Ballpark Dr. Subdivision

July 20, 2004

RE: Proposed Ballpark Drive Subdivision  
ID #2004-0028, CBL #371 A002001

On September 21, 2004 the Portland Planning Board voted unanimously (6-0, Patterson absent) to approve the Ballpark Drive Subdivision in the vicinity of Washington Avenue and Riverside Street, with the following conditions:

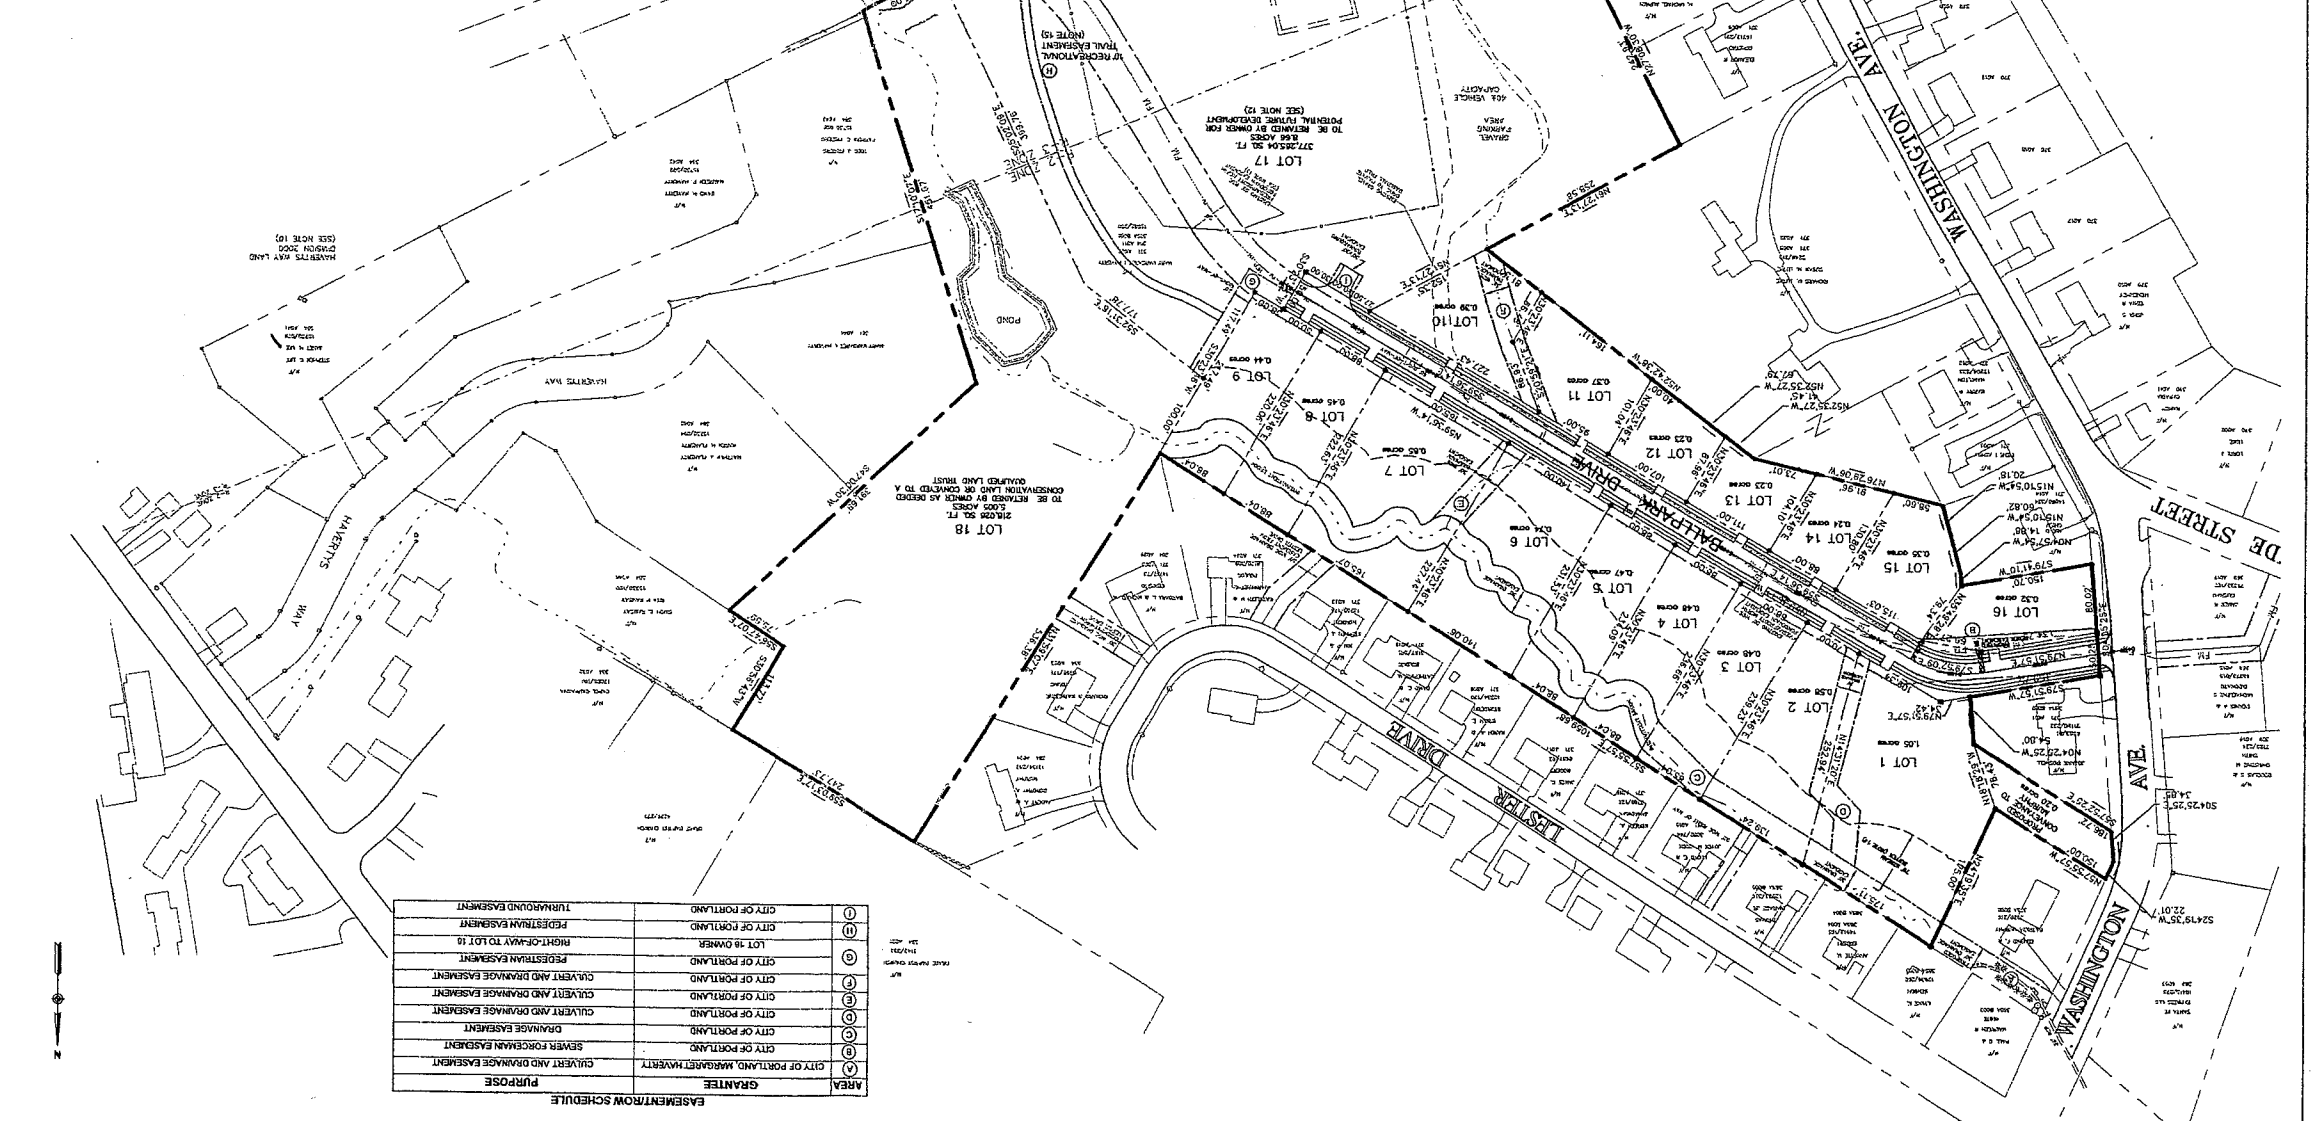
viii. Lot 18 as shown on sheet 1 of the plan set dated September 3, 2004 shall be conserved in perpetuity by deed restriction, conveyance to an approved land trust, or by other legal mechanism subject to final review and approval by Corporation Counsel.

ix. The applicant shall submit revised plans with a 50 foot wide panhandle added to lot 18 so as to provide that lot with its required 50 feet of street frontage onto Ballpark Drive.
